UNITED STATES PATENT AND TRADEMARK OFFICE

APPLICATION NO.	FILING DATE	FIRST NAMED INVENTOR	ATTORNEY DOCKET NO.	CONFIRMATION NO.
10/032,454	01/02/2002	Ulrich Watermann	12383-04/ejg	6577

Office Action Summary

DETAILED ACTION

FIGURE 1

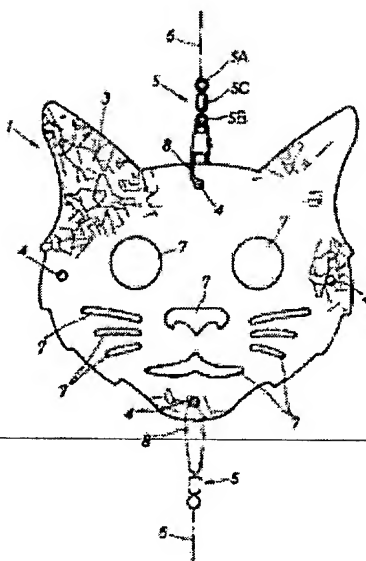
In regards to **claim 1**, Takeda discloses a device for scaring birds comprising a silhouette (1) of a cat having at least one hole (4) therethrough and a first line (6) having one end rotatably attached to the hole (4). See Figure 1 below. Takeda fails to teach a silhouette of a bird of prey as a means of scaring off other birds. However, in U.S. Patent 1,428,216, Chase teaches the use of a silhouette (5) of a bird of prey as a scarecrow. Therefore, it would have been obvious to one of ordinary skill in the art at the time of the invention to modify the scaring device disclosed by Takeda to include a silhouette of a bird of prey, as shown by Chase, in an effort to provide a means of scaring off various species of birds.

Regarding **claim 2**, Takeda as modified, teaches a device further including a swivel (5C) connected to the hole (4). One end of the line (6) is connected to the swivel (5C) so as to permit the silhouette (1) to rotate relative to the line (6). See Figure 1 above.

In regards to **claim 8**, Takeda as modified teaches a device wherein the panel freely rotates about the first and second lines (6). See Figure 1 above.

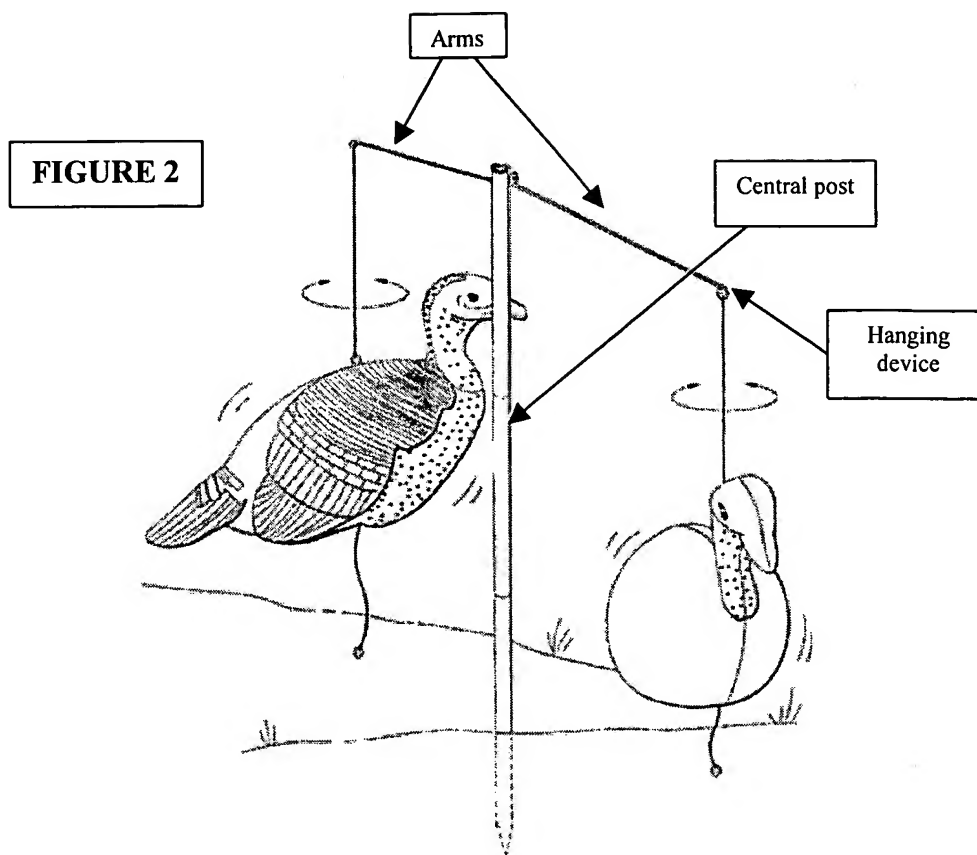
In regards to **claim 3**, Takeda fails to teach an apparatus including a central post for suspending and rotatably moving the silhouette (1). However, Kilgore discloses an apparatus including a central post (16L, 16M, 16U) with extending arms (14B) at the top thereof. The arms (14B) include wind moveable vanes to rotatably propel the arms about the post (16L, 16M, 16U) with another end of the line (14CL, 14CR) hanging from the arm (14B) so as to rotatably move the silhouette (1) about the post (16L, 16M, 16U). See Figure 2 below. Therefore, it would have been obvious to one having ordinary skill in the art at the time of the invention to modify the scaring device disclosed by Takeda, as modified, to include the mounting device, shown by Kilgore, in order to provide a means of moving the scaring device to spook unwanted birds.

In regards to **claim 4**, Takeda, as modified in the previous claim, teaches a device wherein each of the arms (14B) includes a hanging device. See Figure above.
